Background Report for ATM Commercial Subdivision Phase 3

Date : August 24, 2021

LOMR Data (from developer's engineer)
 ATM Commercial Subdivision
 City of Willard

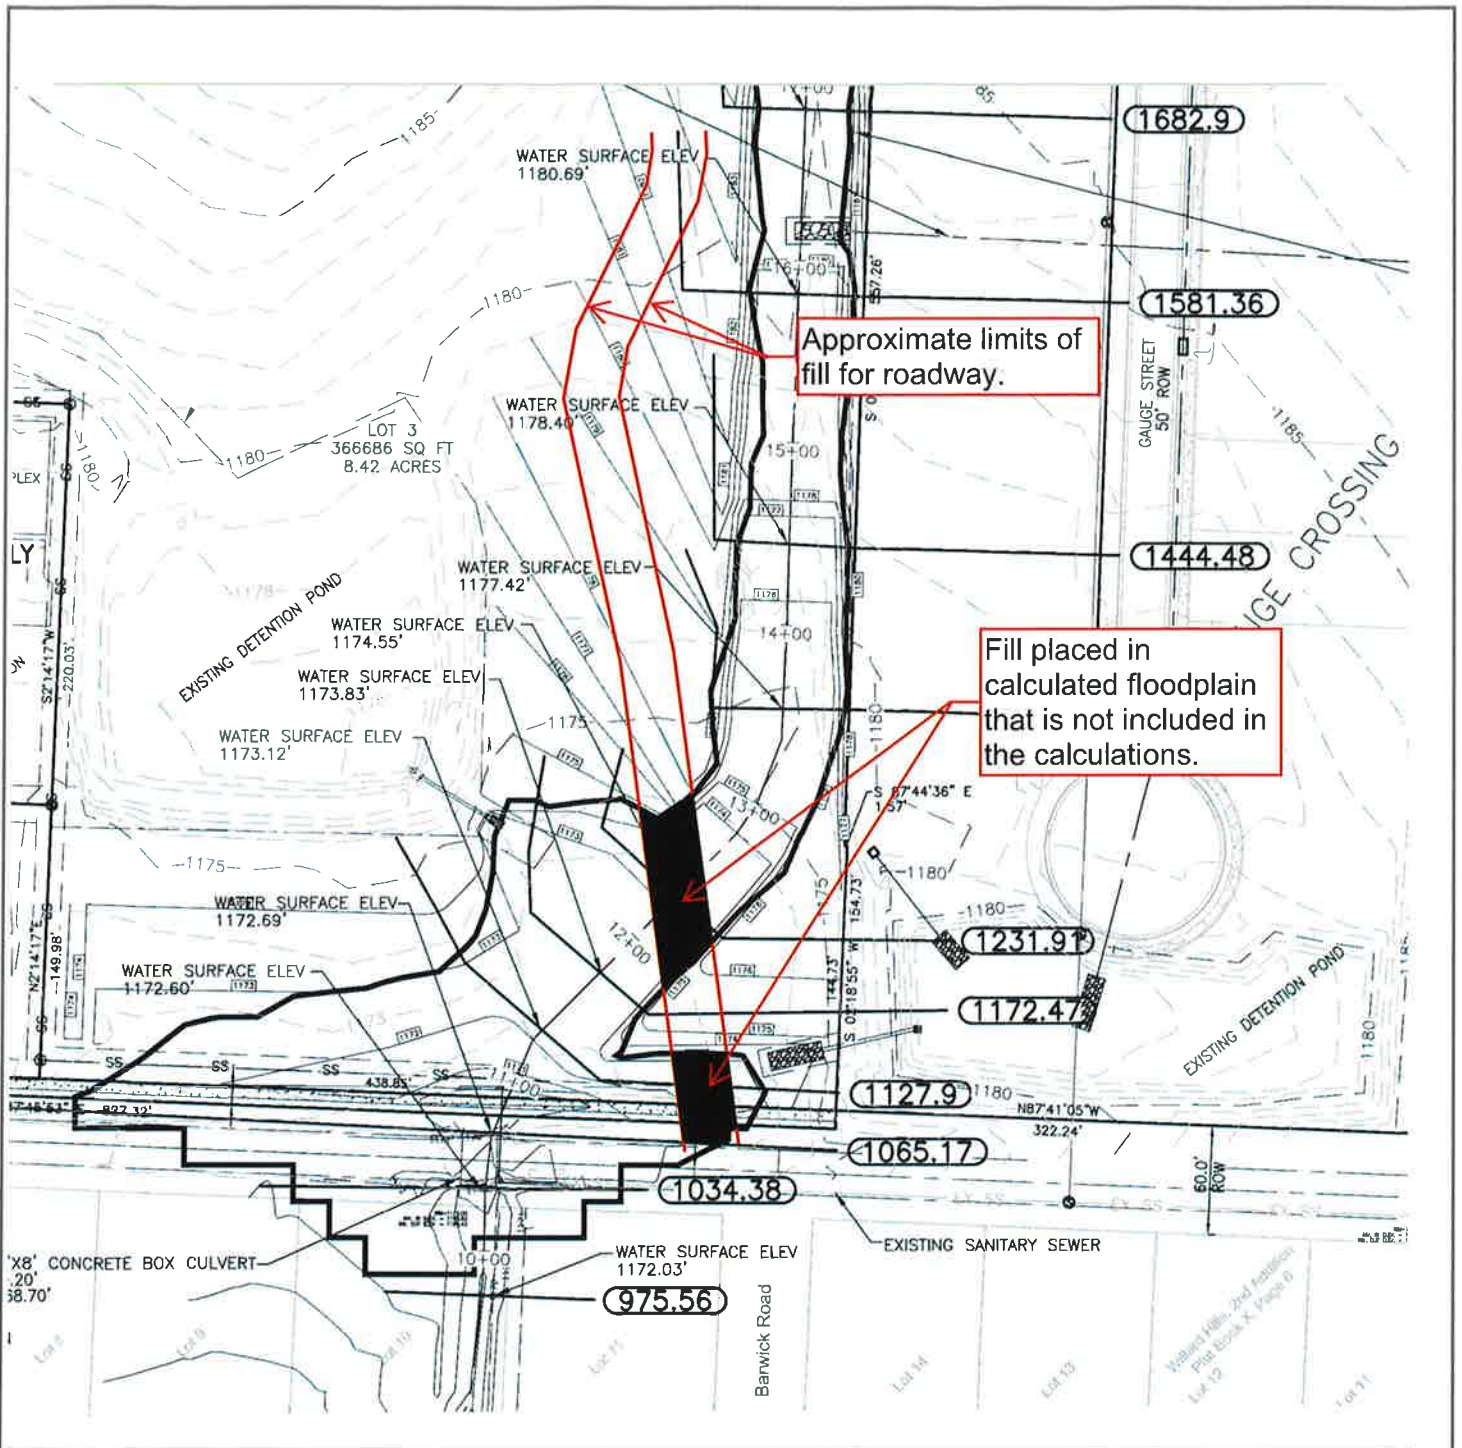
The fill placed (for the road) was not included in HEC-RAS files nor in the two pdf's.

The roadway fill is clearly placed inside the limits of the:

effective FEMA Zone A floodplain map,
and the preliminary FEMA Zone AE floodplain map (including both the floodplain and floodway)
and proposed floodplain map as presented by calculation.
(SEE ATTACHED PDF)

FEMA PRELIMINARY FLOODPLAIN AND FLOODWAY (data from SEMA);
 ATM Commercial Subdivision

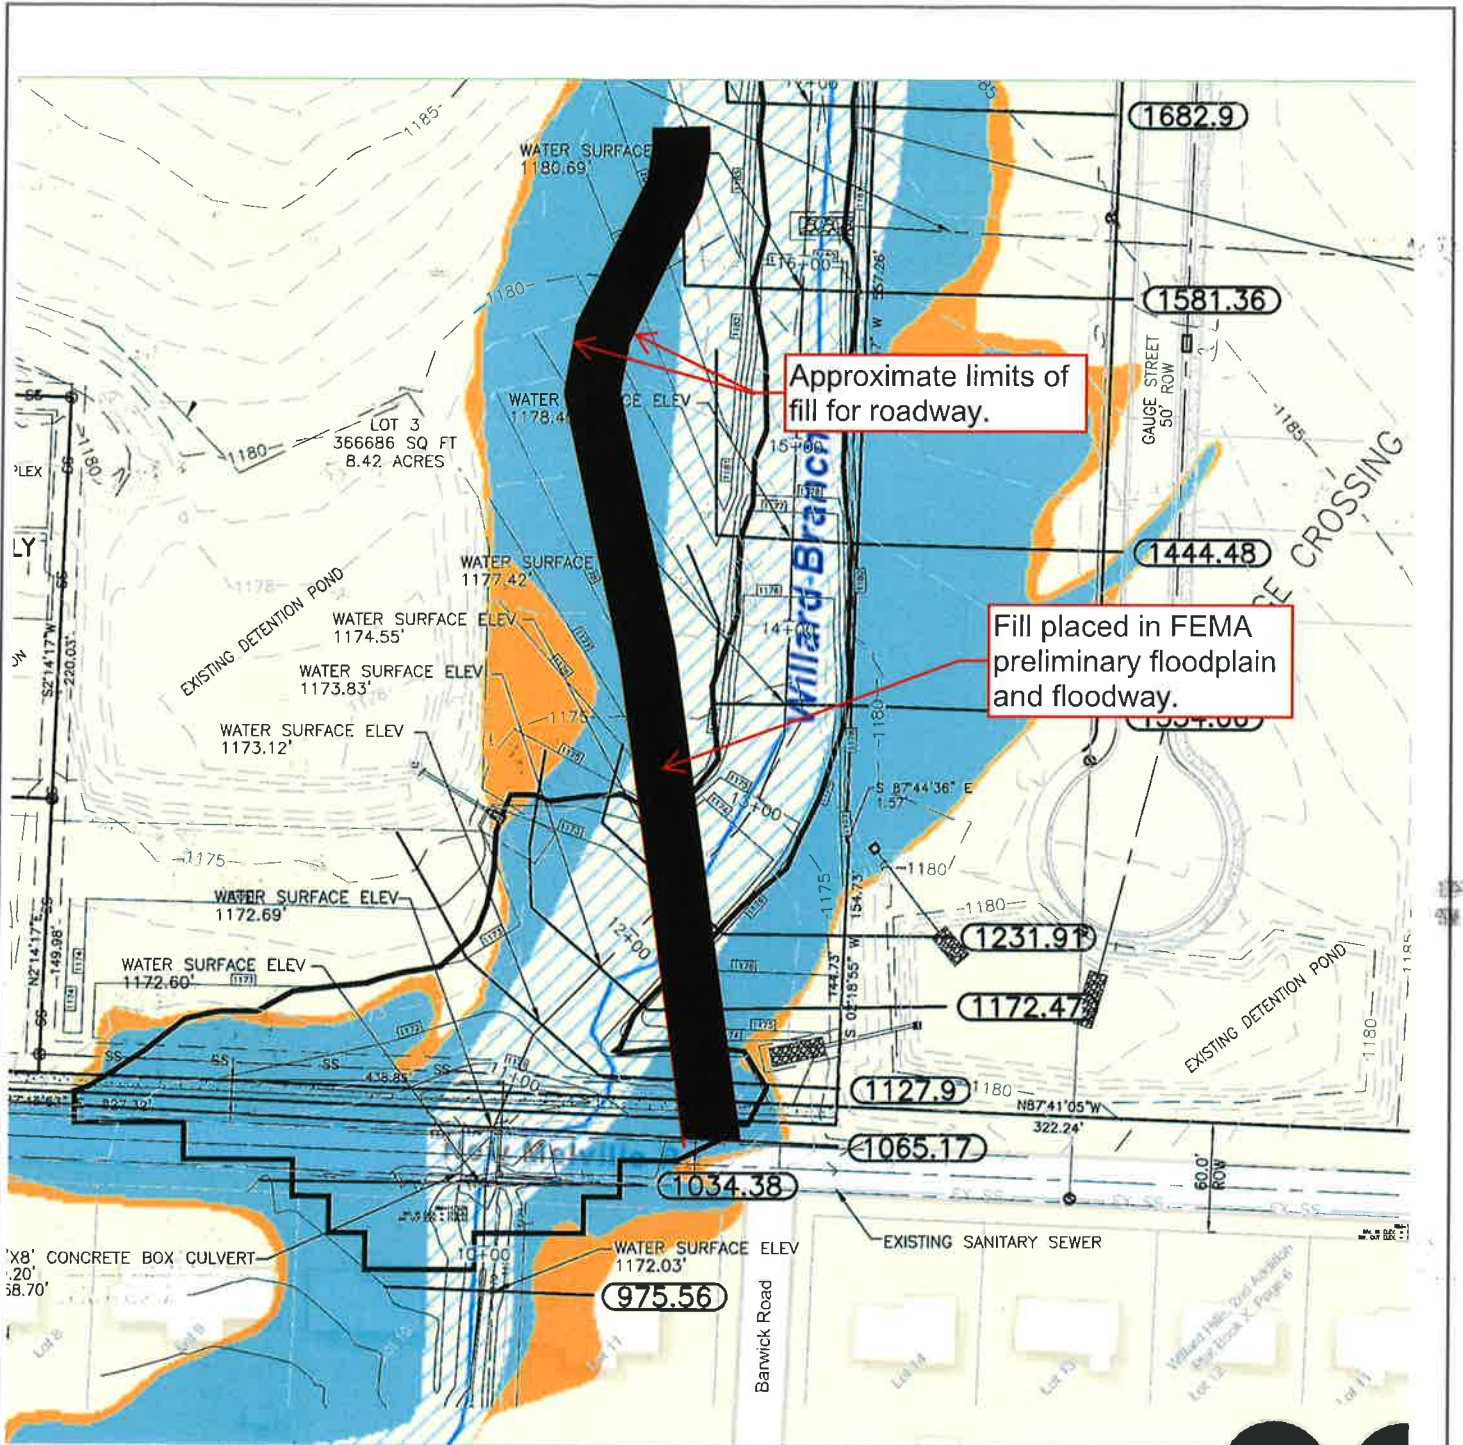
Approximate limits of fill for roadway.

Fill placed in FEMA preliminary floodplain and floodway.
